REMARKS

Brief synopsis of changes to the claims:

Fig. 3

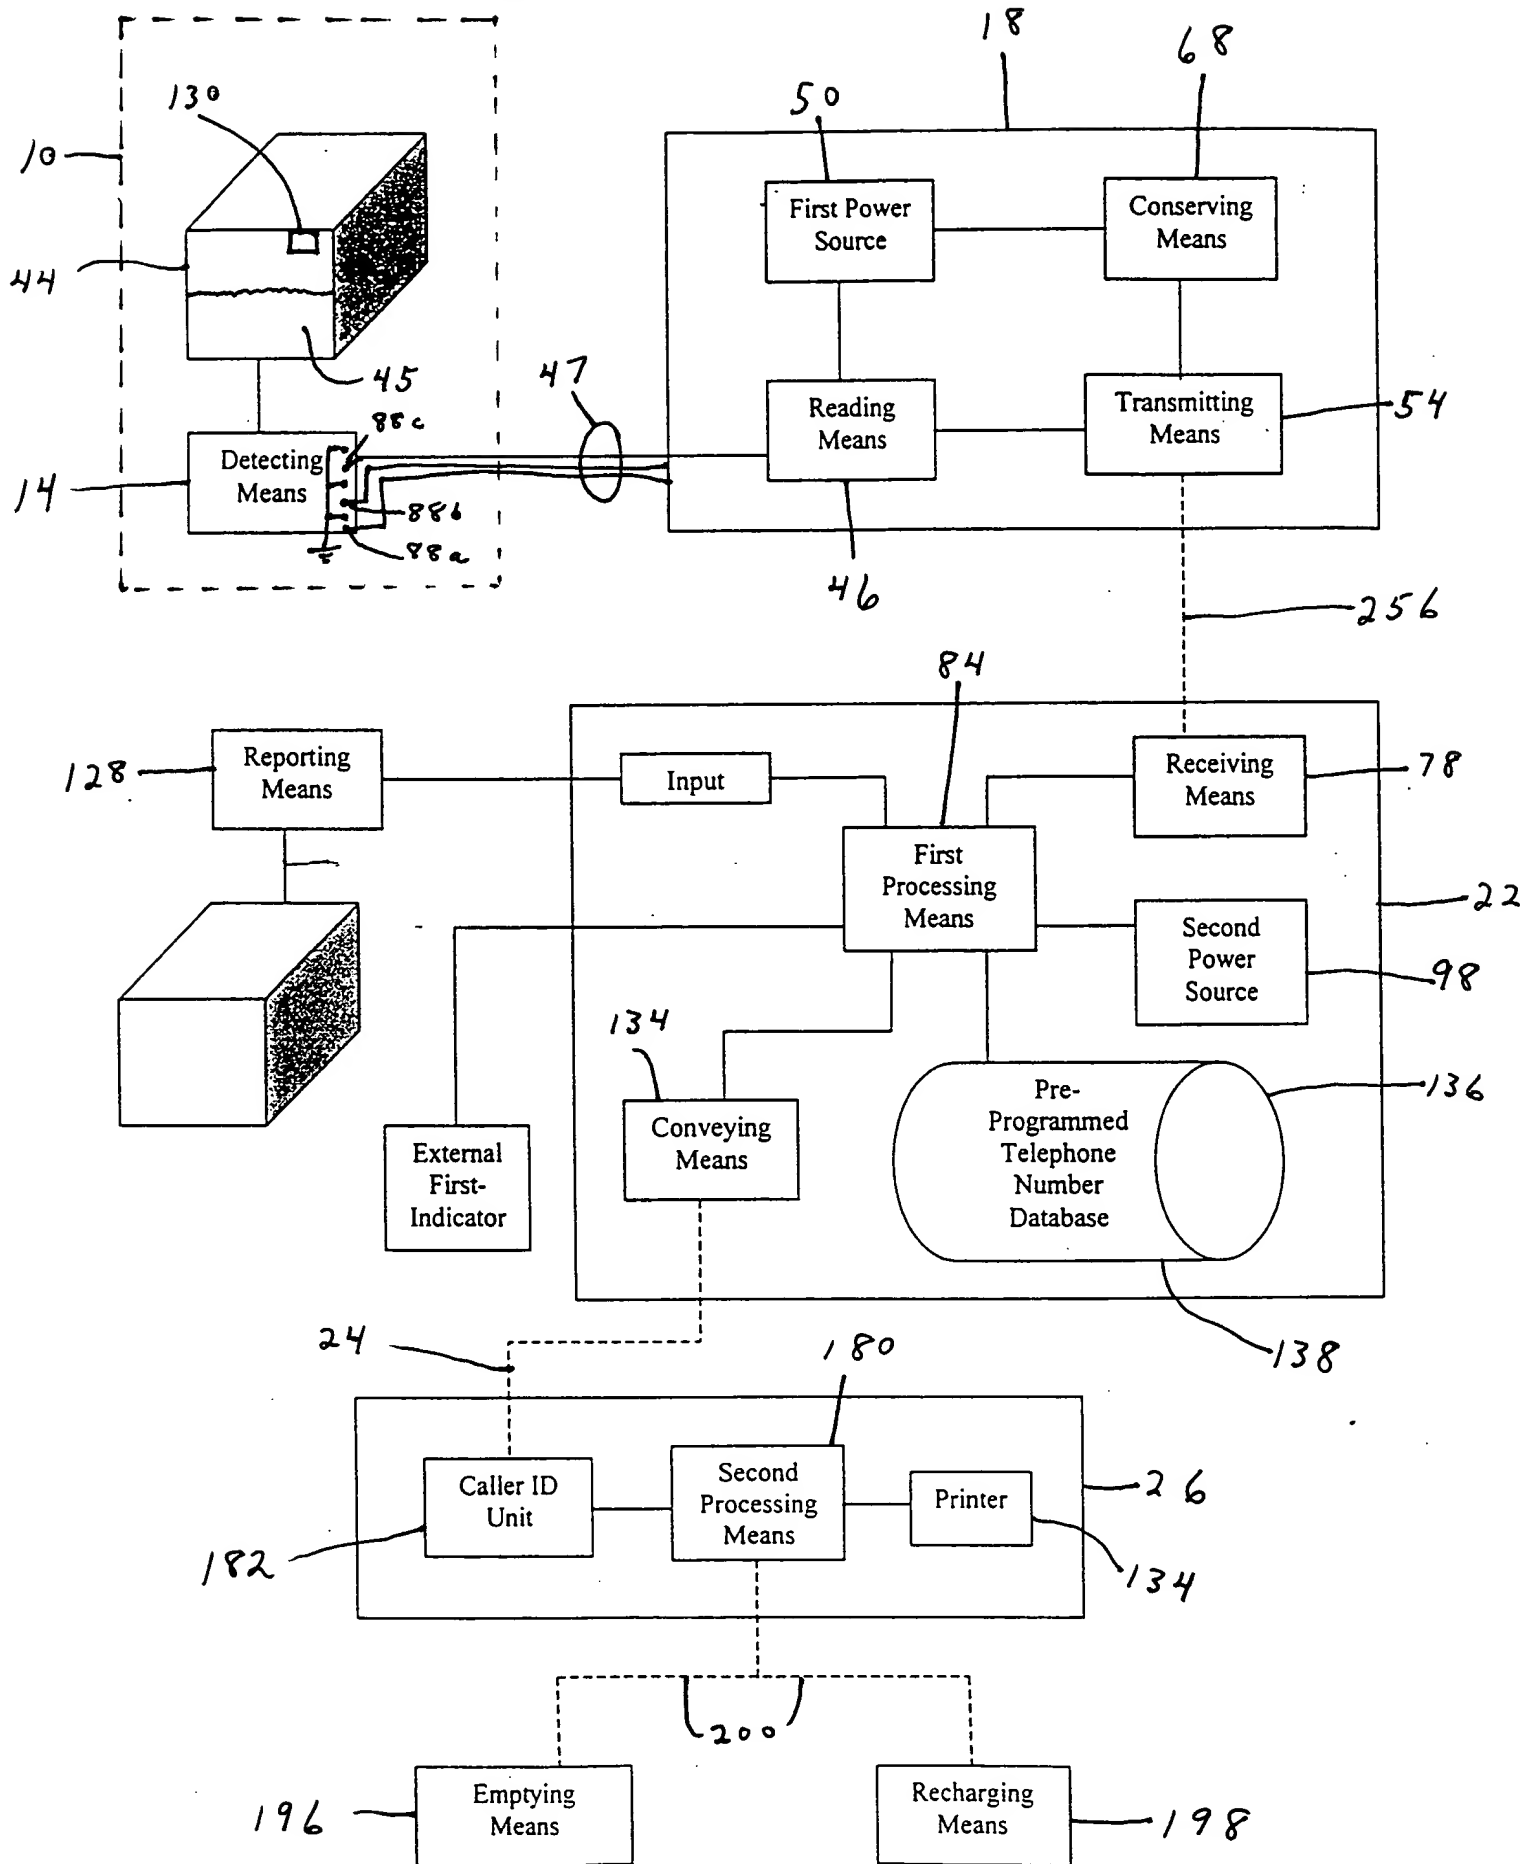
In particular, in the **first letter to the draftsman**, reference characters have been added to each of the drawings, and in figure 3, a representation of the material 45, line 47, contacts 88, and ranging unit 130 have each been added. These features are all clearly disclosed in the original specification and claims.

Fig 3A

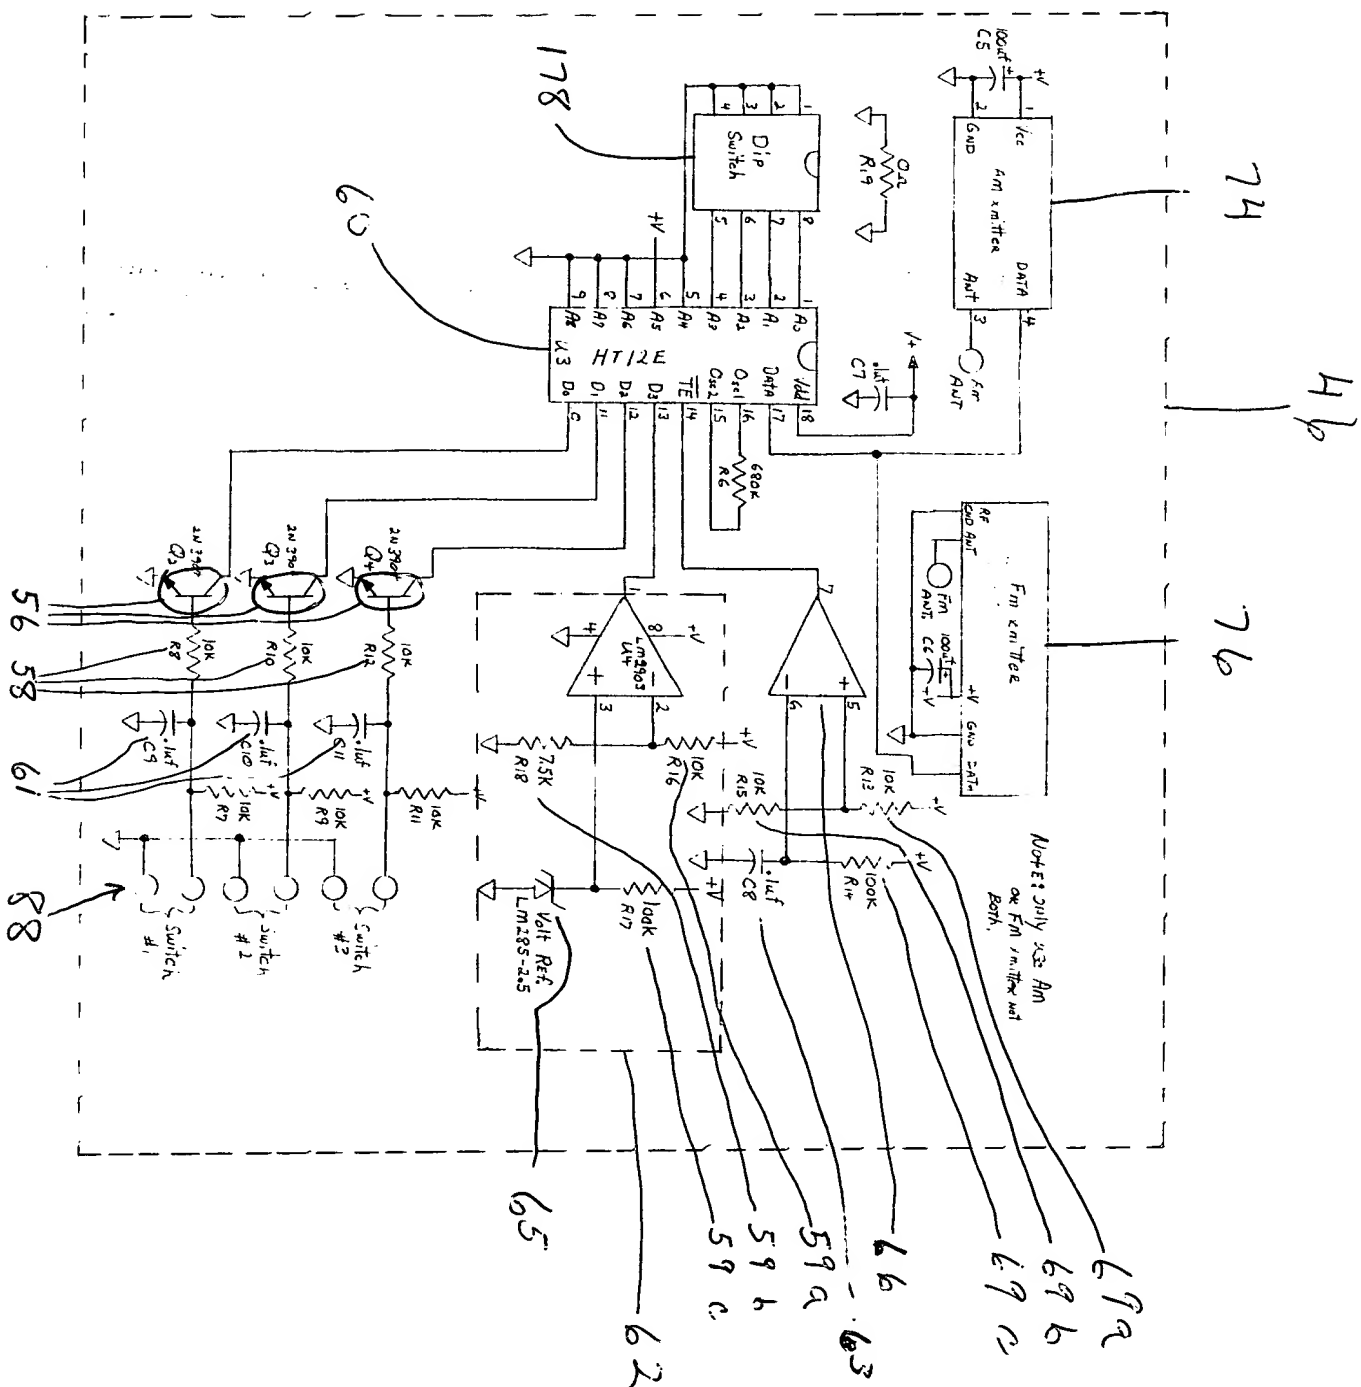
In a **second letter to the Draftsman**, two new drawings have been added, as figures 3A and 3B. Support for these new drawings can be found throughout the specification.

More especially for figure 3A, support is found in the original specification at page 11, line 3 through page 12, line 20. Support for figure 3A can also be found in original claims 17, 19, 20 and 21, and in the new, substitute specification at page 13, line 12 through page 16, line 11.

Fig 3B

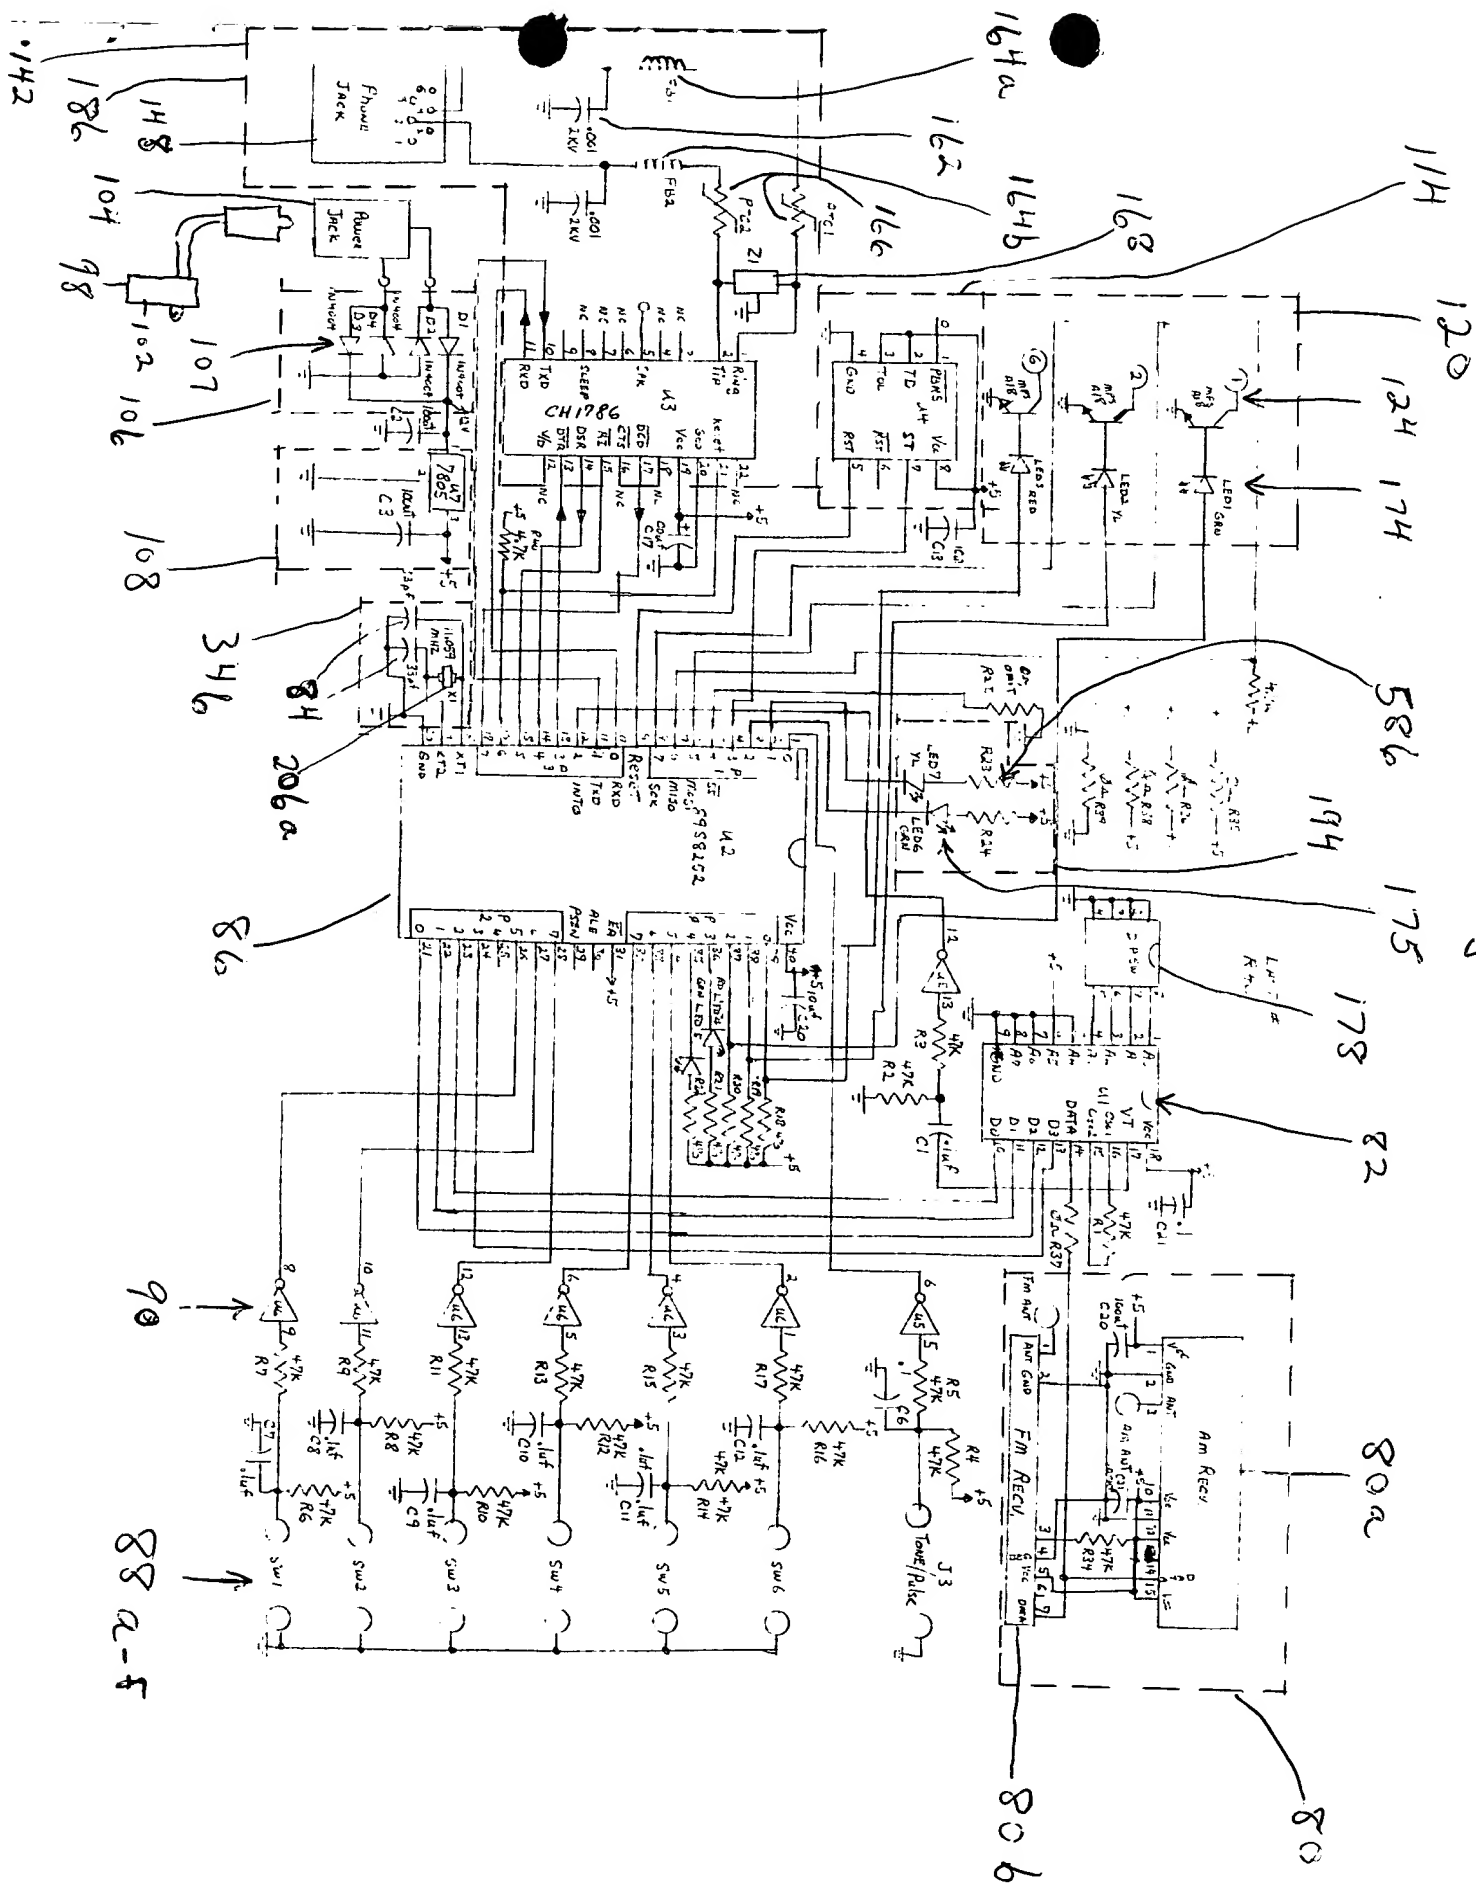
For figure 3B, support is most directly found in the original specification at page 13, line 1 through page 16, line 10, as well as in original claims 26-28, and 47-50, and also in the substitute specification at page 16, line 12 through page 22, line 22.
